# TANSA

WATER SUPPLY PROJECT.

OCTOBER 1885.

MUNICIPAL COMMISSIONER'S OFFICE,  
BOMBAY, 13<sup>th</sup> October 1885.

DRAWING N<sup>o</sup> 3

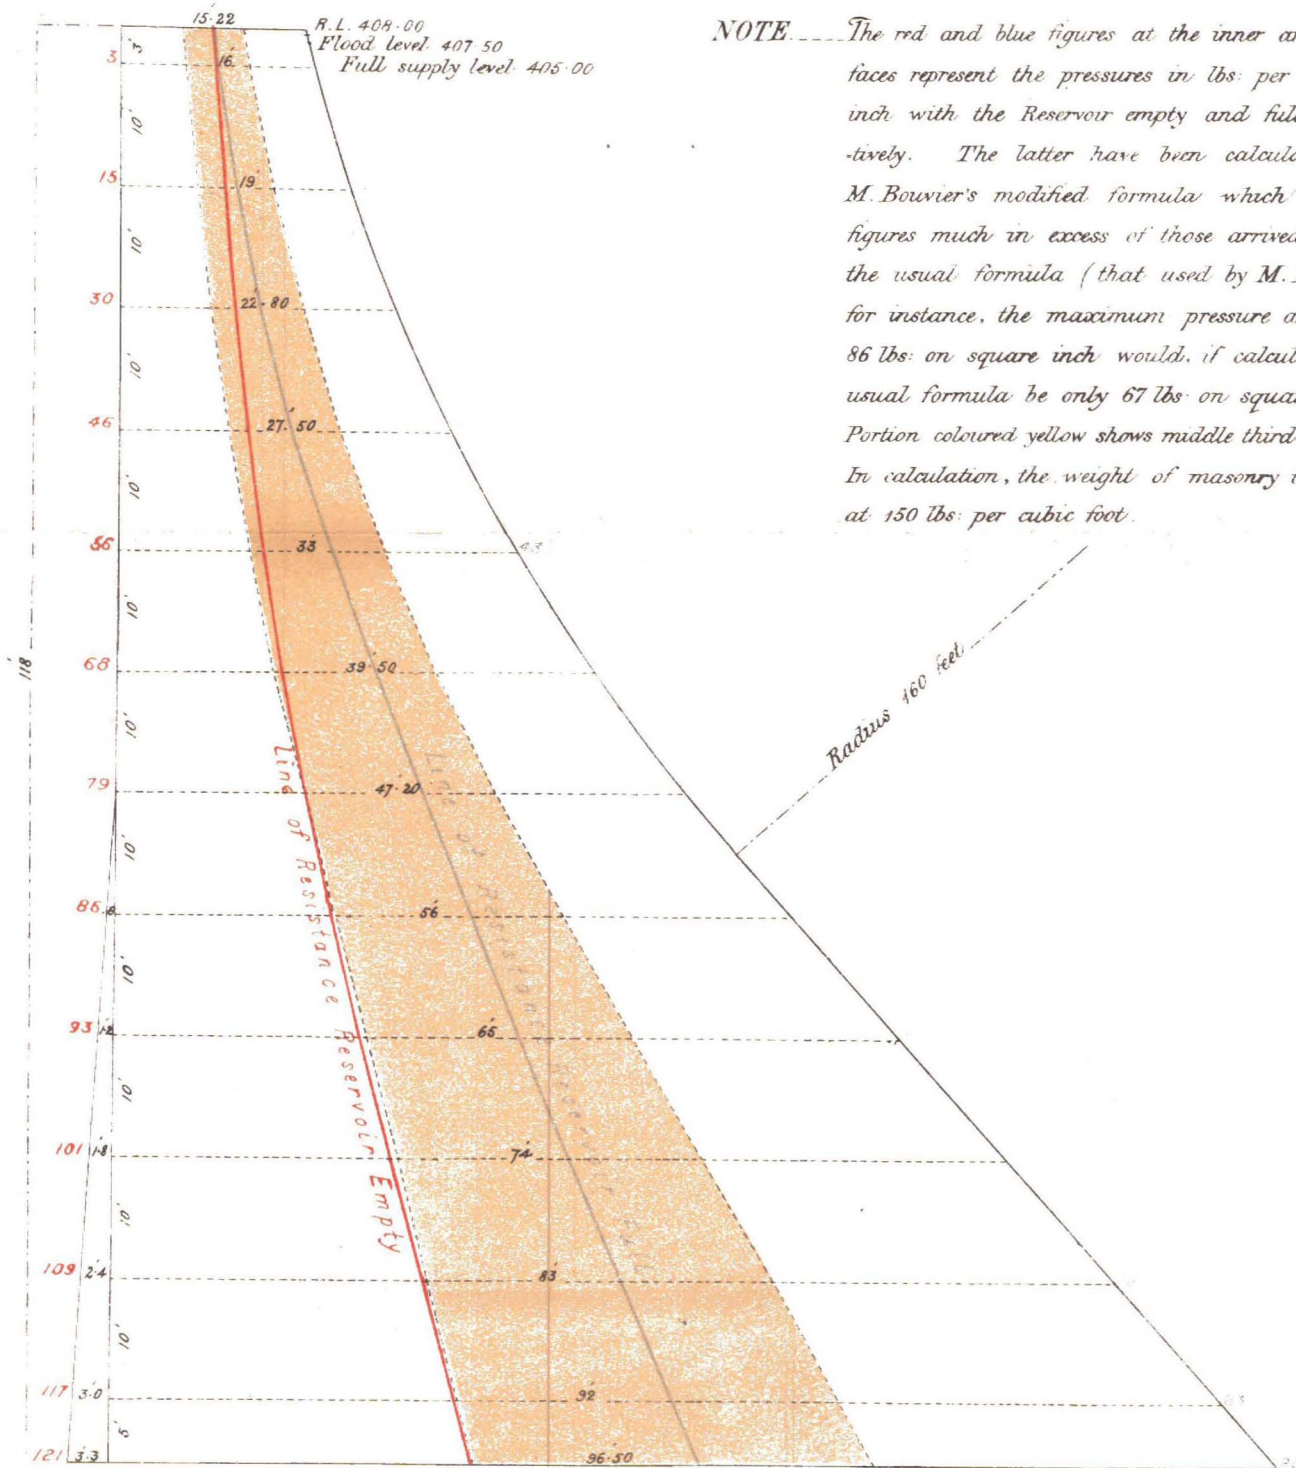
6. In para. 7 Mr. Clerke discusses the section of the proposed masonry dam, taking for the purposes of calculation 150 lbs. as the weight of a cubic foot of masonry. The specific gravity of the Tansa stone is doubtless the same as the Tulsi stone, where the masonry is 155 lbs. per foot.

## OUTLET WORKS

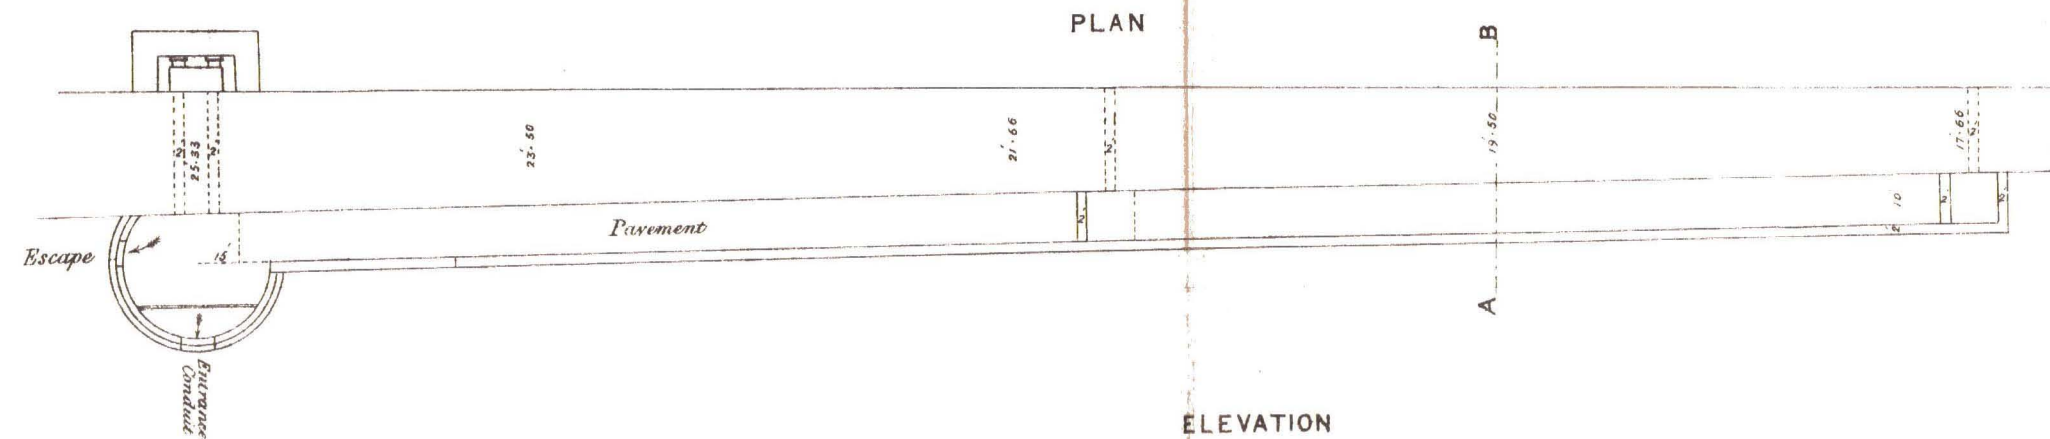
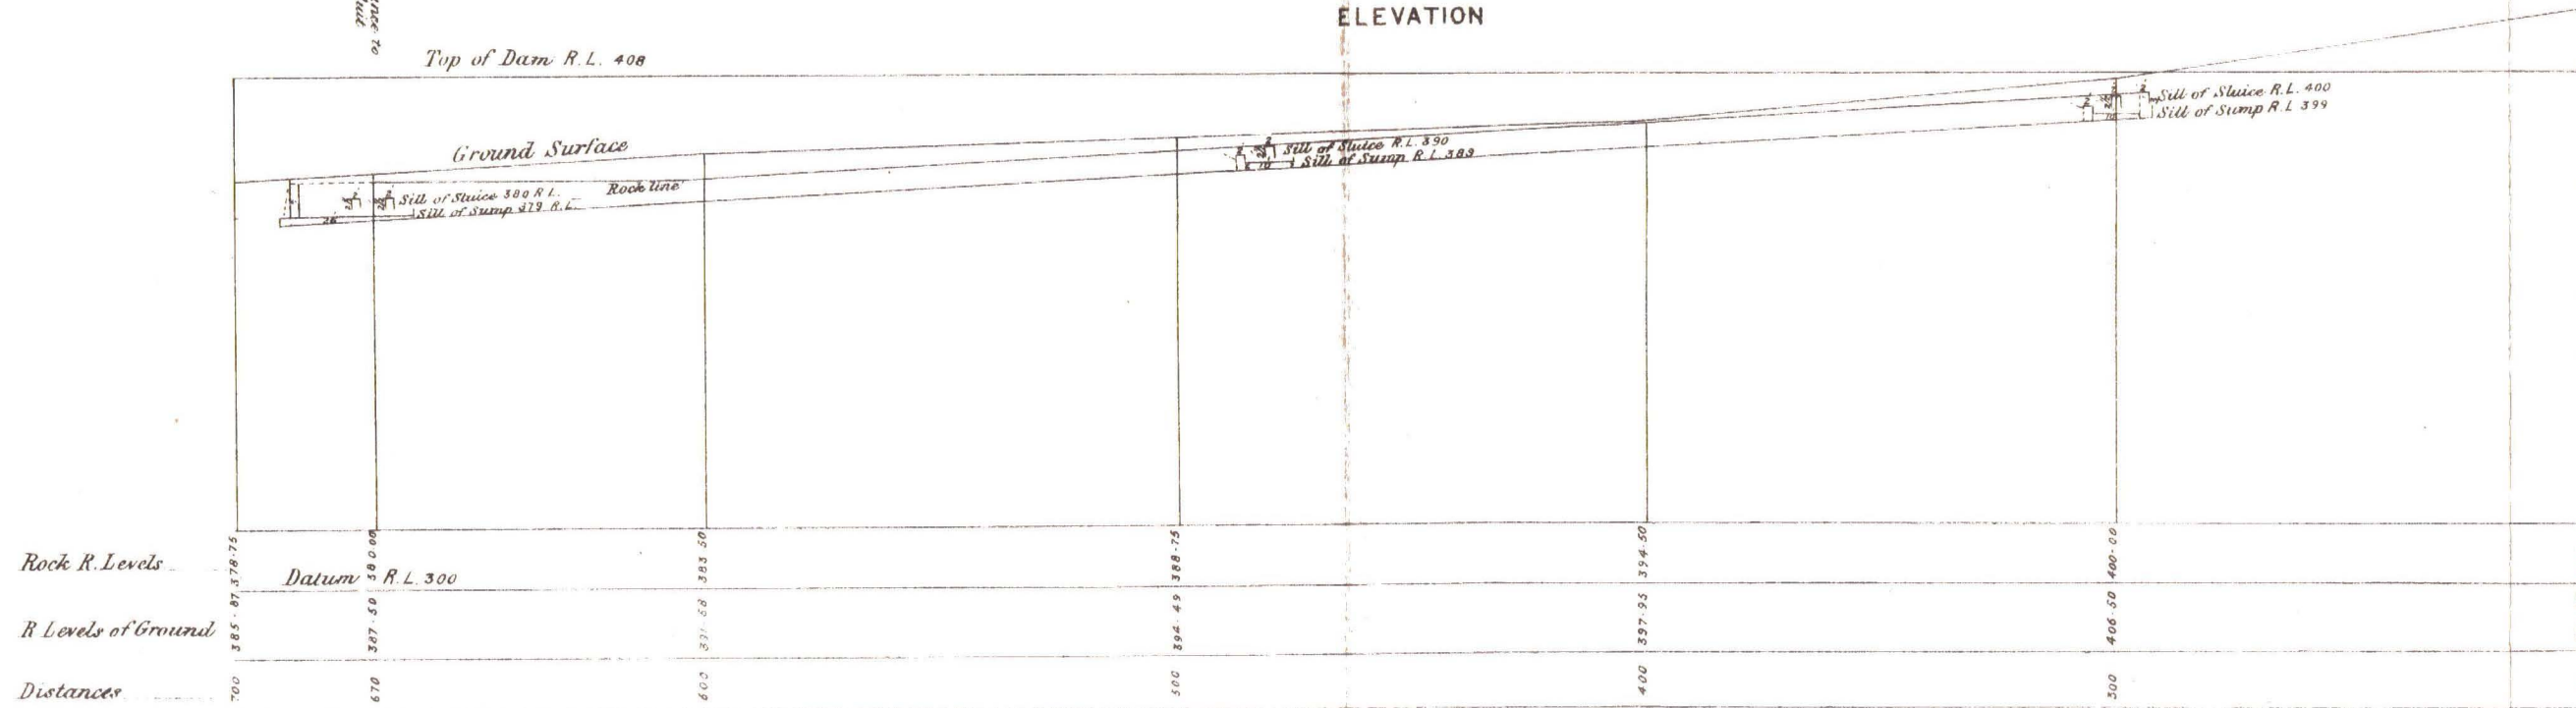
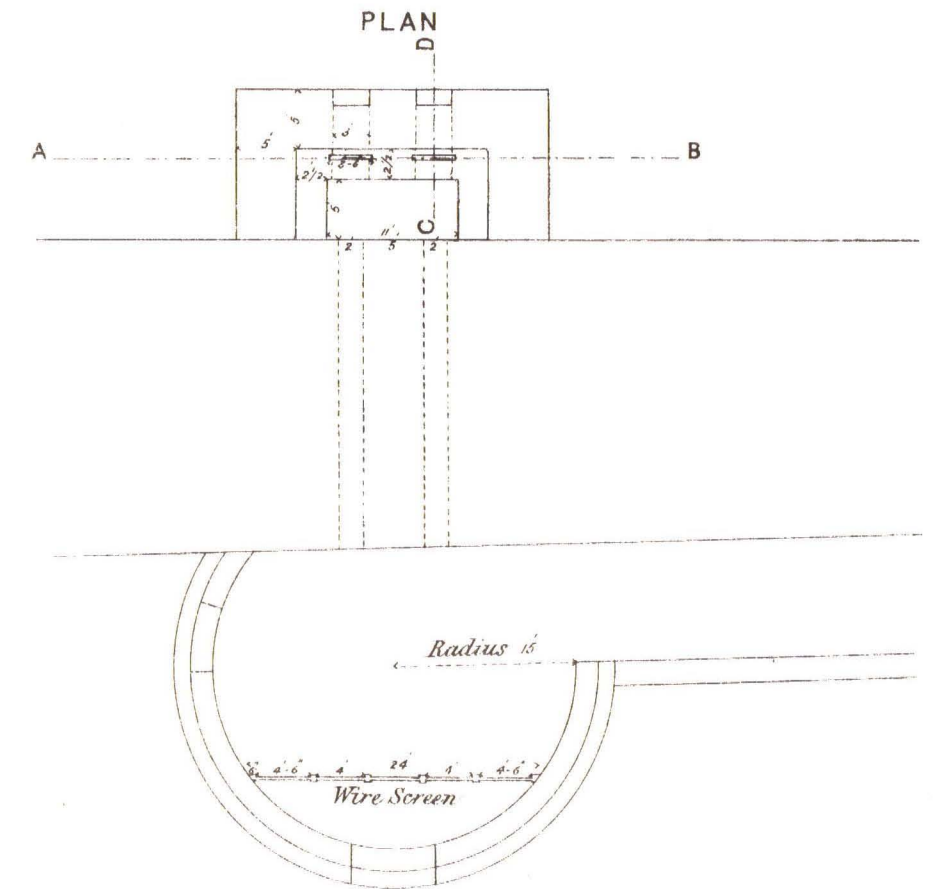
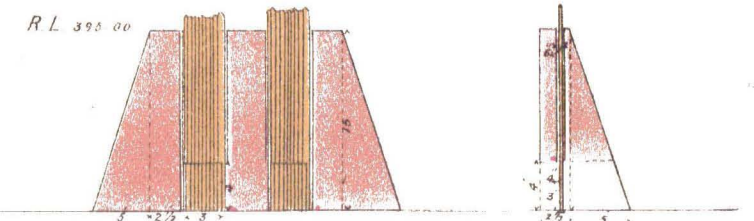
7. The method of drawing off water from the reservoir proposed by Mr. Clerke is preferable to that designed by Major Tulloch, being less expensive and less complicated.
